Packing List# 37113 Rel# 1 PAGE 1
Metalex Job# 2005-3803

CERTIFICATE OF CONFORMANCE

ITEM	QTY	PART NUMBER	REV	PART NAME	ID # *
0002	1	L143-110700	07	Strongback	5A06990-06

REV. DATE BY DESCRIPTION
Metalex
CERTIFIED ISO 9001
QUALITY MANAGEMENT
STRONGBACK DEVIATION
ARGONNE
T.J.RAUCH
17AUG05
T.J.RAUCH
17AUG05
FULL
INCH X METRIC
2 2 3801
AutoCAD Release '14
DRAWING No.
SDR 3801-004
REV.
D

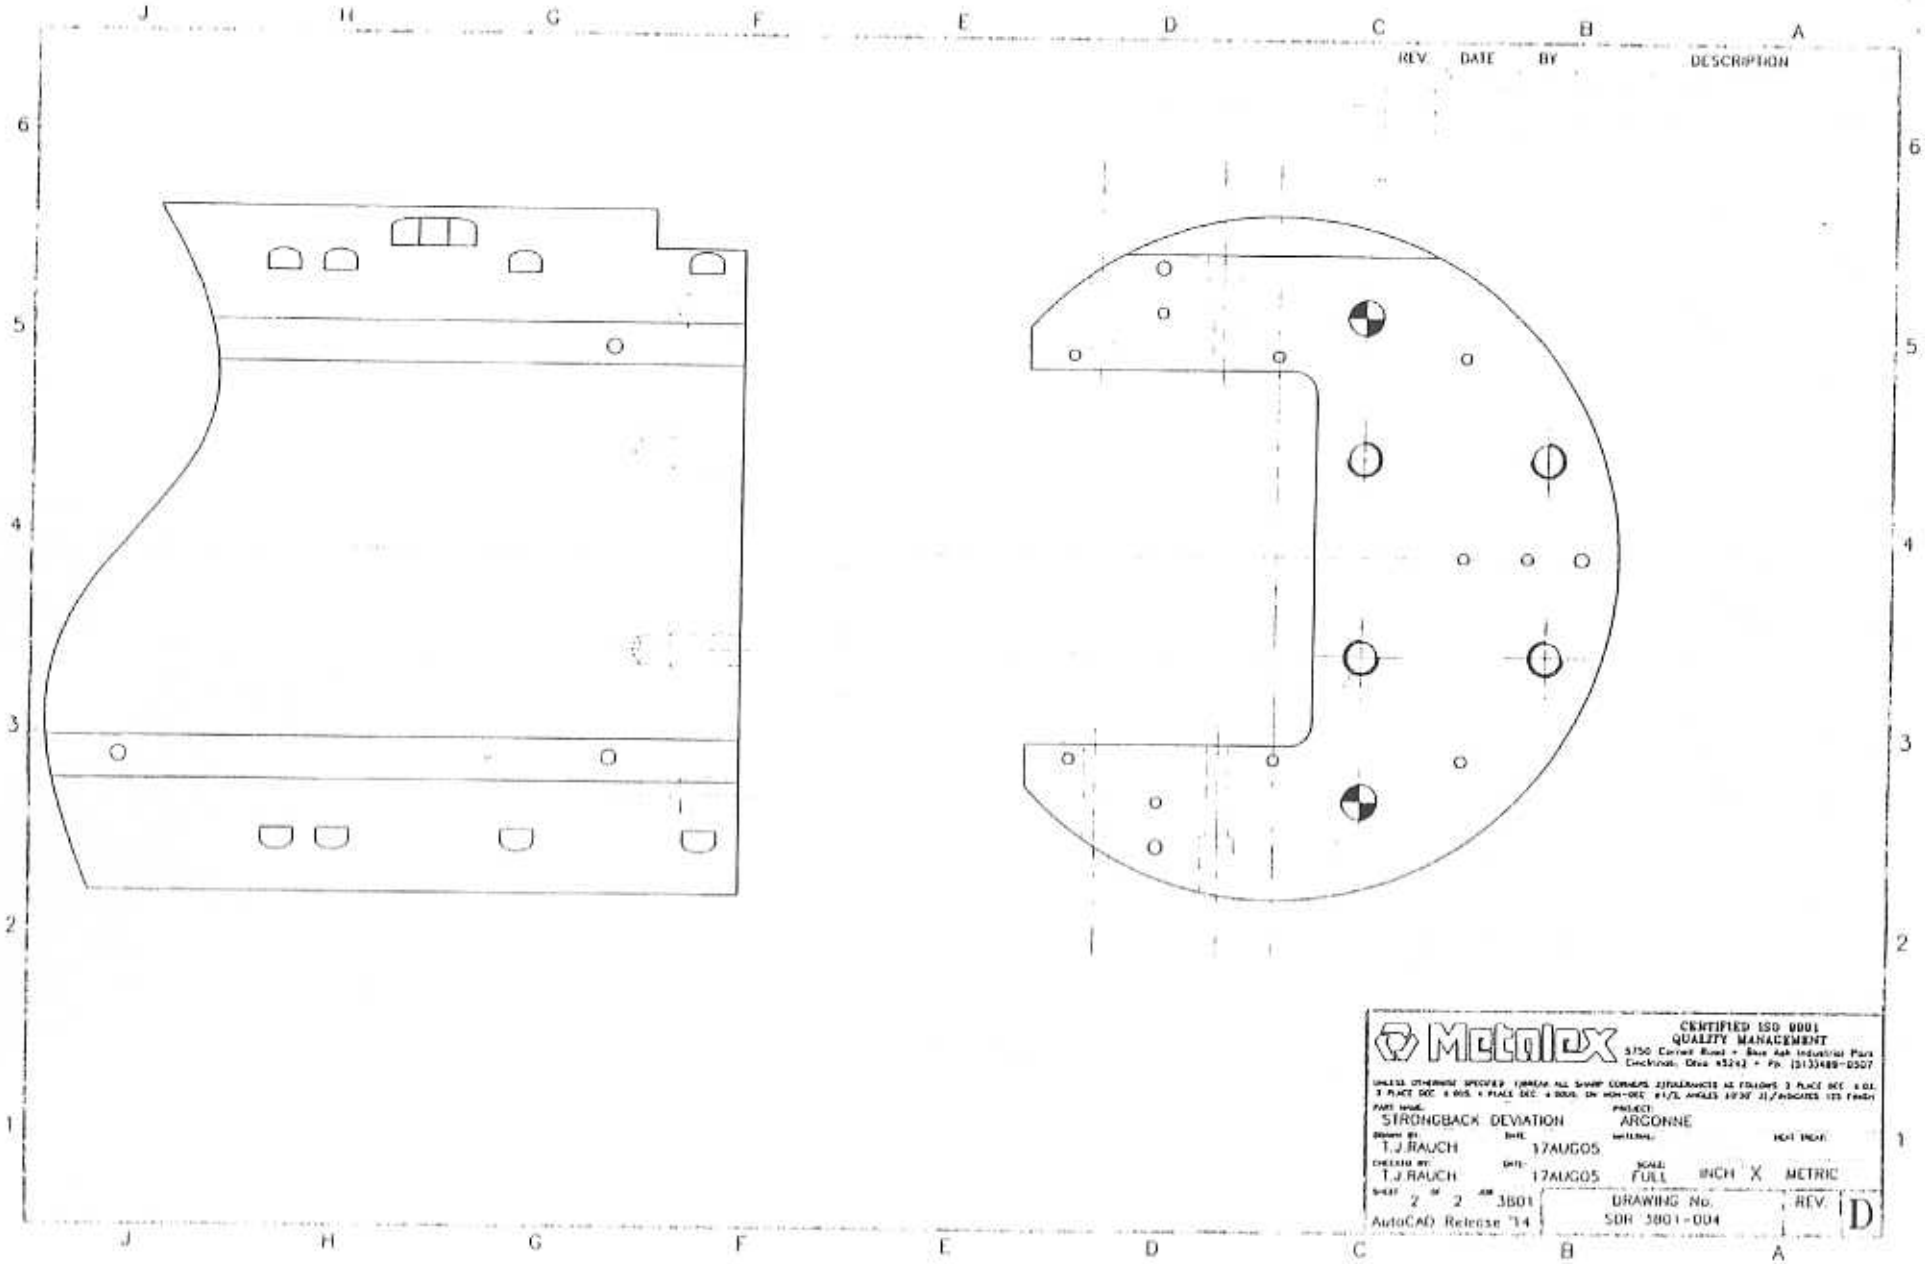
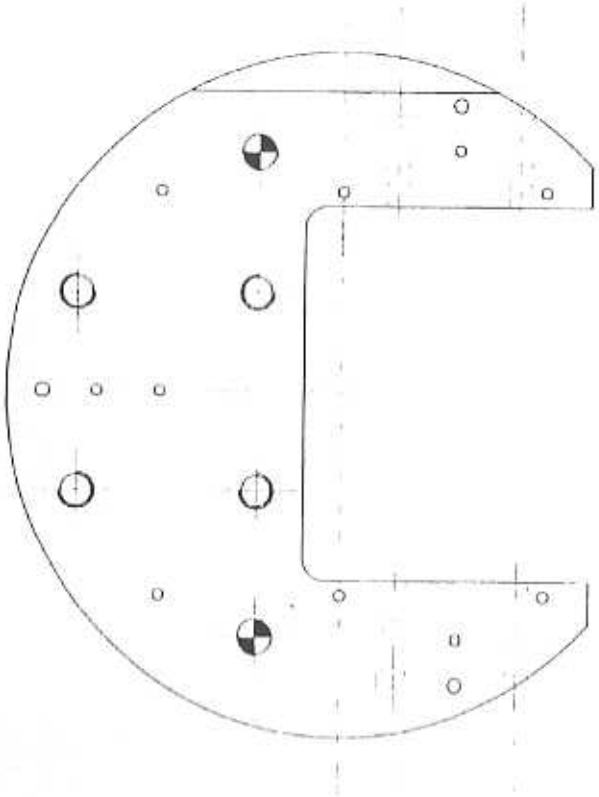
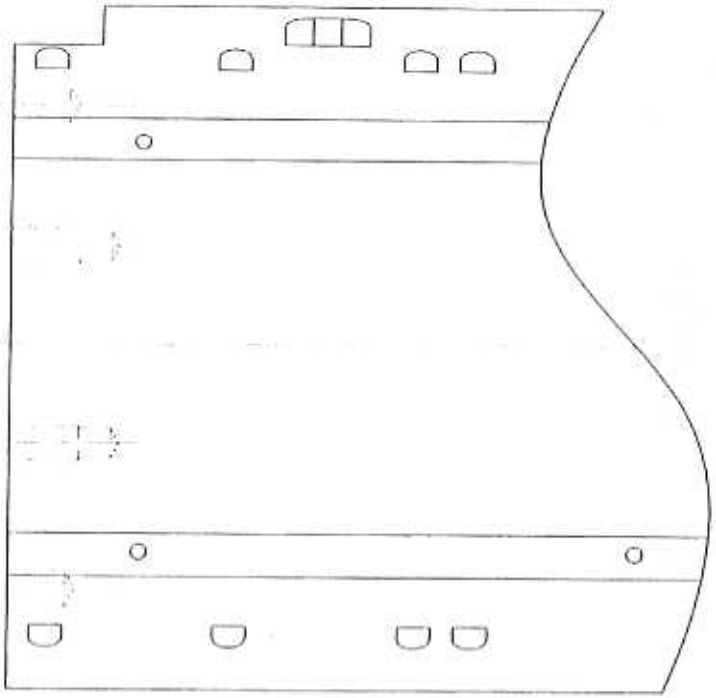
7. Qty.	8. Describe Nonconforming Condition	9. Identify Requirement	10. Cause & Corrective Action
	1) Along with this form, Metalex has attached a sketch named SDR 3801-004, pages 1 and 2. This sketch outlines some additional "for manufacturing process only" holes that Metalex is requesting permission to add to the Strongback details. On each end of each part, (4) 5/8-11 tapped holes and (2) .6250" diameter dowel pin holes are requested to be added for internal use at Metalex.	Metalex requests direction from ANL on this item.

17. ANL Disposition and Remarks: The requested modifications for internal Metalex use are allowed.

PART NAME: STRONGBACK PROCESS		PROJECT: ARGONNE			
DRAWN BY: R.SCHUERMANN	DATE: 03NOV05	MATERIAL:			HEAT TREAT:
CHECKED BY: R.SCHUERMANN	DATE: 03NOV05	SCALE: FULL	INCH	X	METRIC
SHEET 1 OF 2	JOB 3801	DRAWING No. MXPL143-110700-03		REV.	D
AutoCAD Release 14

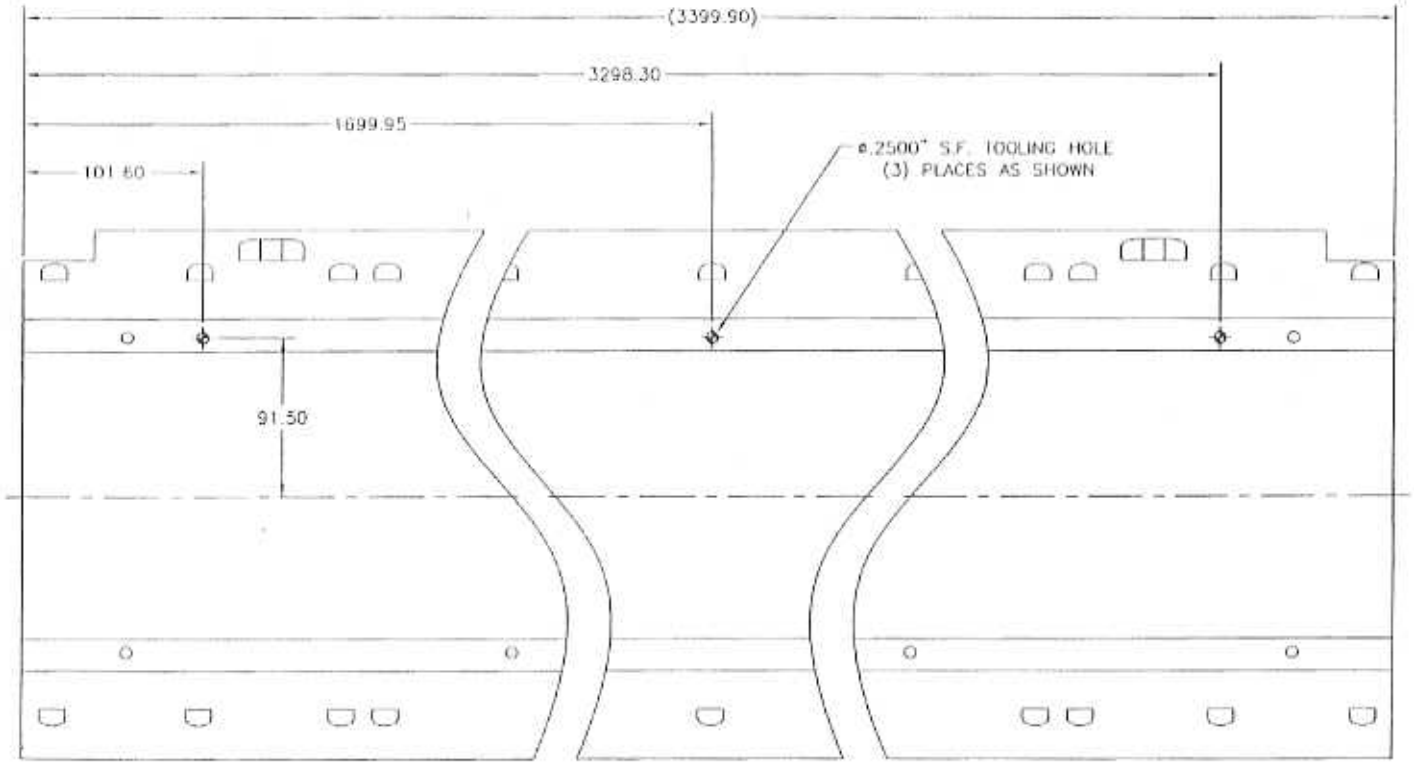
7. Qty.	8. Describe Nonconforming Condition	9. Identify Requirement	10. Cause & Corrective Action
	1) Along with this form, Metalex has attached a sketch named MXPL143-110700-03. This sketch outlines some additional "for manufacturing process only" holes that Metalex is requesting permission to add to the production Stongback details. These three (3) .2500" diameter tooling holes located as shown will allow ease of manufacturing and inspection of the critical overall length of this detail.	Metalex requests direction and approval from ANL on this item.

These three (3) 2500" diameter tooling holes located as shown will allow ease of manufacturing and inspection of the critical overall length of this detail

17. ANL Disposition and Remarks: Acceptable
